# Evaluation of Seismic Risk for VC Summer Under the Process for Ongoing Assessment of Natural Hazard Information (POANHl)

January 25, 2024

# POANHI Seismic Hazard

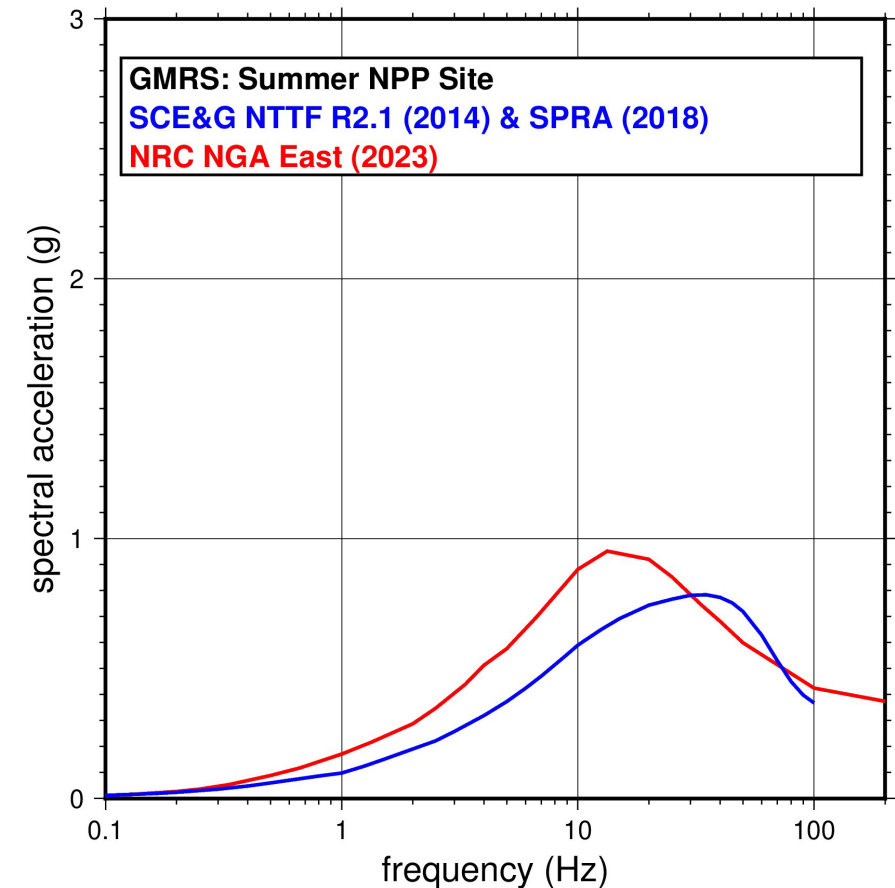
- Figure shows ground motion response spectra (GMRS) from NRC staff's recent evaluation (**red**) compared to previous evaluations resulting from Near Term Task Force Recommendation 2.1 (**blue**)
- NRC staff's recent evaluation developed used latest models
  - NGA-East ground motion model
  - Central and Eastern U.S. seismic source model (NUREG 2115) including update to seismicity catalog to remove dependent events and reservoir induced earthquakes in South Carolina
  - Because Summer is a hard-rock site NRC staff's evaluation did not implement a site response analysis
